Service Engineering Operations
Customer Service Division

SUBJECT: Special Field Action 24L04
Certain 2017 and 2020-2022 Model Year Super Duty Vehicles Equipped with 6.7L Engine - Emission Control Information Label Update

Special Field Action 24L04

FIGURE 1

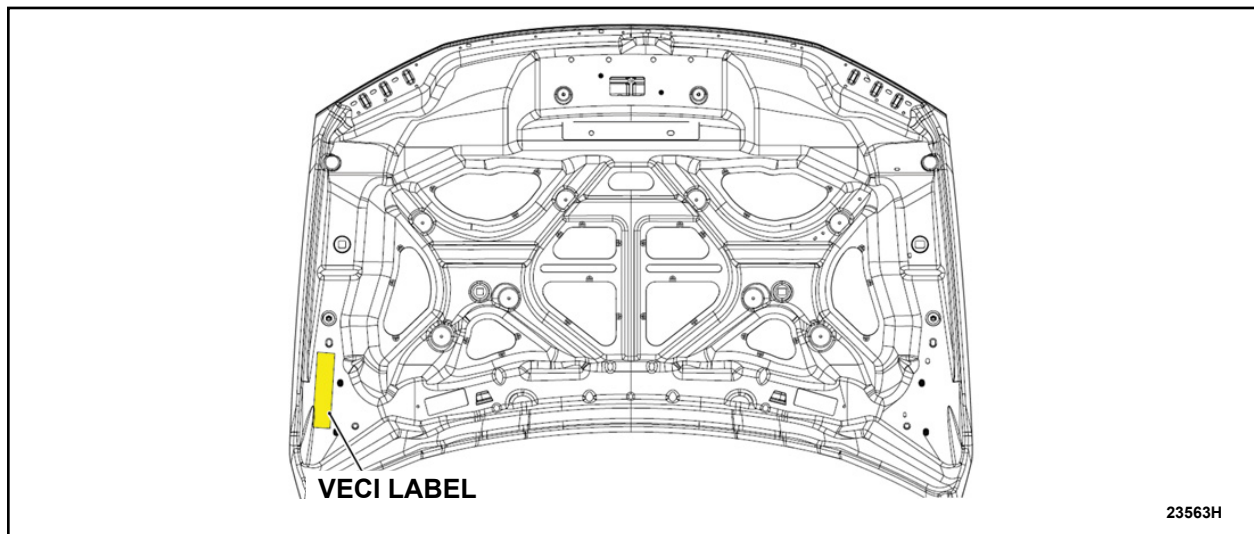
The affected vehicles were built with an Emission Control Information label affixed under the hood, and in some cases also on the engine, that does not include the correct emissions standards applicable to the vehicle.

1. Confirm the two (2) appropriate Emission Control Information labels for 24L04 have been received by checking for High Sulfur Diesel text on the lower left corner of the labels. See Figure 2.
2. Open the hood.
3. Locate the existing Emission Control Information label on the inside of the hood. See Figure 1.

4. Use a cleaner/degreaser and a clean shop towel to clean the existing label and the area around it.
5. Use a lint free shop towel/paper towel and wipe dry the existing label and the area around it.

6. Place the first *new* Emission Control Information label, shown below, directly over the original label.
See Figure 2.

FIGURE 3

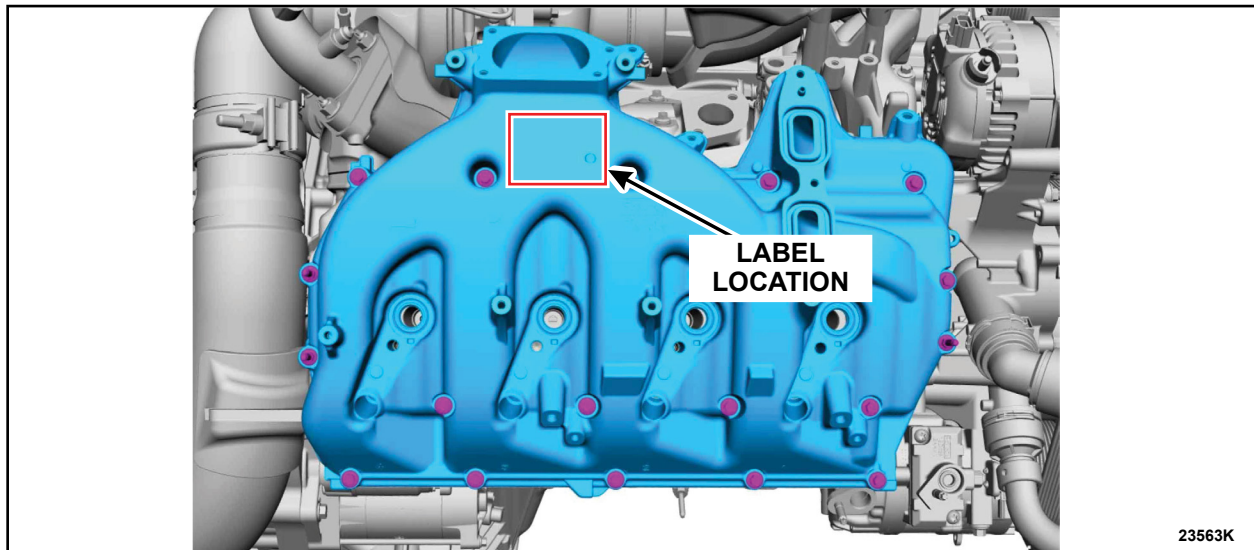
NOTE: A label may or may not already be present, depending on the vehicle.

8. To install the label, the engine should be cool to the touch. Remove any loose or partially attached labels and clean the surface of any existing emission control label, if present and fully attached to the engine, with cleaner/degreaser, or clean the top surface of the valve cover with cleaner/degreaser if no label is present.
9. Use a lint-free cloth/paper towel and wipe dry the top of the valve cover and/or existing label.

10. Place the second *new* Emission Control Information label (see Figure 2) on the valve cover and directly over the original label, if one is present. See Figure 3.
